# Backfeed in a 4-pair context v230

**Lennart Yseboodt**

May 14, 2018

## Cause of backfeed in the PD

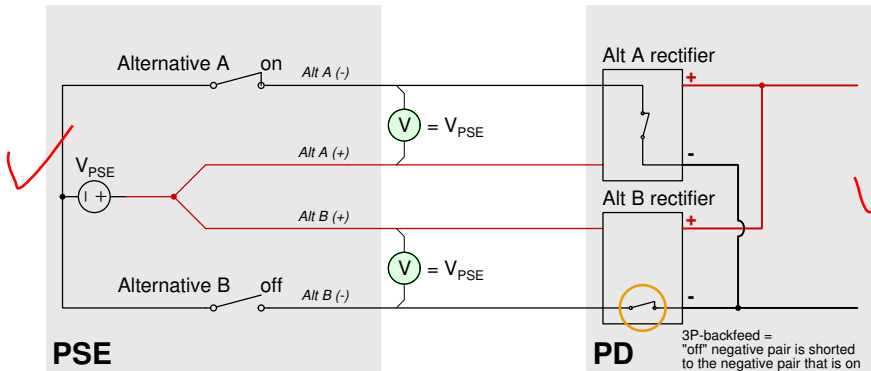
Just like the PSE shorts the positive pairs together, the some PDs short the negative pairs together when exposed to 3-pair power ( $2 \times$  positive and  $1 \times$  negative voltage).

It is not the same.  
PSEs is shorting the positive leads deliberately. They have good reasons why to do it.  
PDs doesn't do it. It happen due to design mistake. The connection exists only at the inputs of the bridge (due to PSE). Actually, the PD can't do it deliberately, otherwise mant things will not work including insensitive to polarity..

# Detection corruption issue

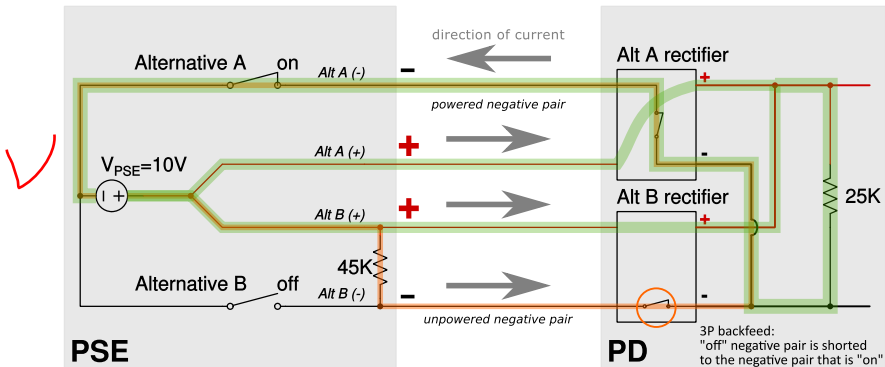
If the PSE ties an "off" negative pair to the positive (via a discharge resistor) and the PD connects the negative pairs together, this causes this resistor to appear in parallel to the PD detection resistor.

⇒ **PDs may not tie negatives together in the detection voltage range.**

## Classification offset issue

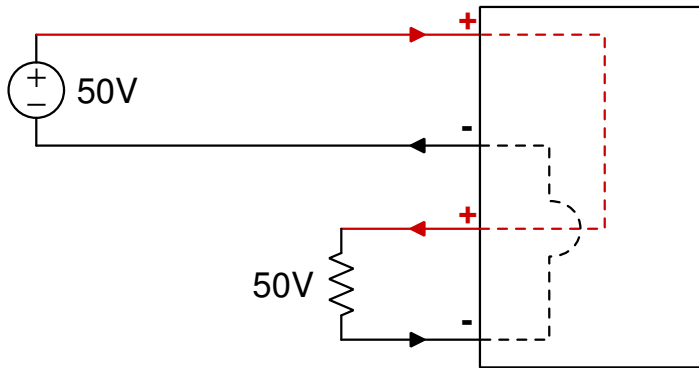
✓ During classification the same PSE discharge resistor can increase the observed class current. With a  $45\text{ k}\Omega$  resistor, the maximum offset current is  $20.5\text{ V}/45\text{ k}\Omega = 456\text{ }\mu\text{A}$ . There is 1 mA of margin between the PD and PSE classification signature current spec, which can absorb this. **Today these margins are too tight. Now it worsens.**

It requires that the permitted PSE reverse current is limited to about  $500\text{ }\mu\text{A}$  in the classification range.

**Now it increases probability that Class 1 will be read as class 2 etc.**

## PD shall not source power issue

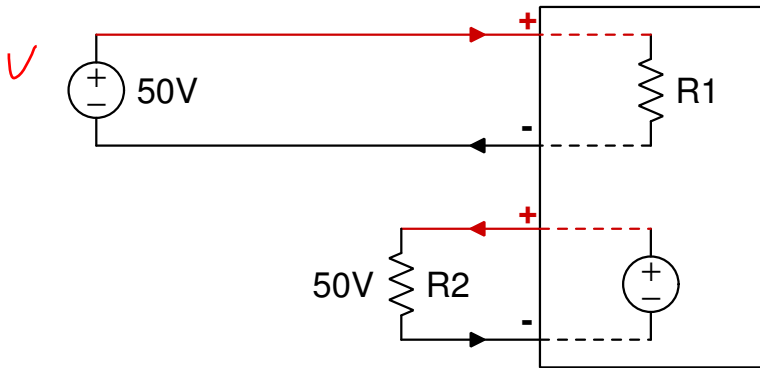
✓ Backfeed is different from sourcing power, even though in both cases a voltage appears on the PD PI.

**This is sourcing power on the PI:**
